TRICON SUBDIVISION

APPLICATION NUMBER 7 DATE September 6, 2007

DETAIL SITE PLAN

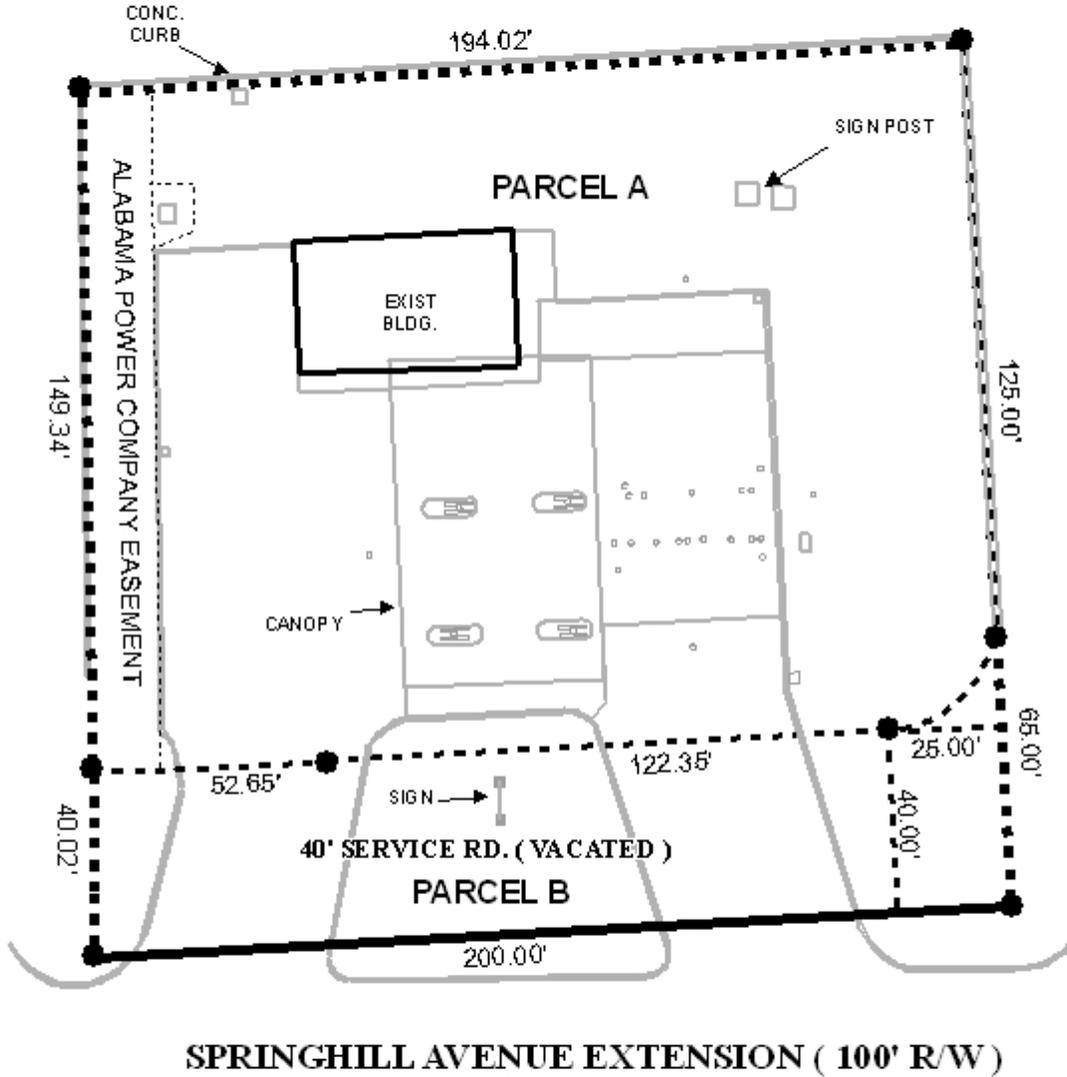
The site fronts Spring Hill Avenue which has a 100' right-of-way in this area, compliant with the Major Street Plan. Therefore, no right-of-way dedication is required. The plat did not indicate a minimum building setback line; therefore, a 25' minimum building setback line along Spring Hill Avenue should be depicted on the final plat.

The site has two existing curb cuts to Spring Hill Avenue and this would be consistent with the allowance for the 200'+ street frontage. A note should be placed on the final plat stating that the site is limited to two curb cuts with the size, location and design to be approved by Traffic Engineering and conform to AASHTO standards.

No lot size was indicated on the plat; therefore the final plat should be revised to label the lot with its size in square feet, or a table should be provided with the same information.

1. the depiction on the final plat of the 25' front setback line along Spring Hill Avenue;
2. labeling of the lot with its size in square feet, or the provision of a table on the final plat with the same information;

3. placement of a note on the final plat stating that the site is limited to two curb cuts, with the size, location, and design to be approved by Traffic Engineering, and conform to AASHTO standards; and
